# Access Compliance Report

## Public Rights-of-Way

### (Curb Ramps)

Intersection ID: 14071	Main Street: CLEVELAND_AV	Cross Street: E_KINGSTON_AV	Location: E
ADA ID: 918C5B5CDA6D	Ramp Type: Directional1	Initial Pass/Fail: Fail	Overall Compliance: No
			Severity Score: 13.75

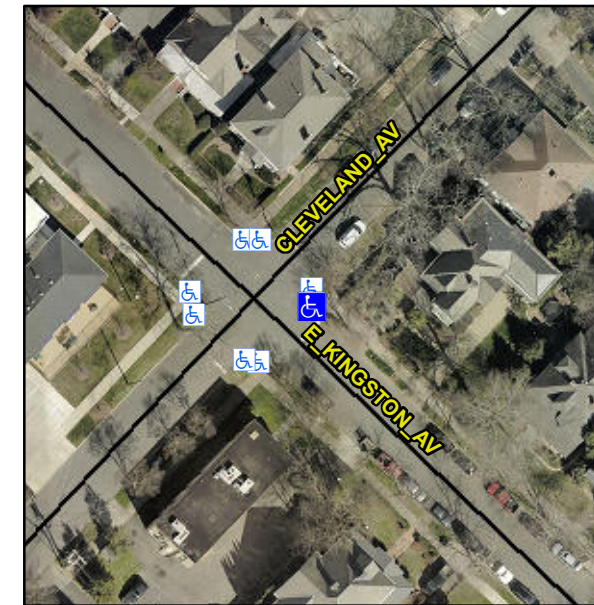
**NO CURB LINE, ASP LIP 1.0"**

**R304.2.2, R304.5.3**

**Remove & Replace Entire Ramp.**
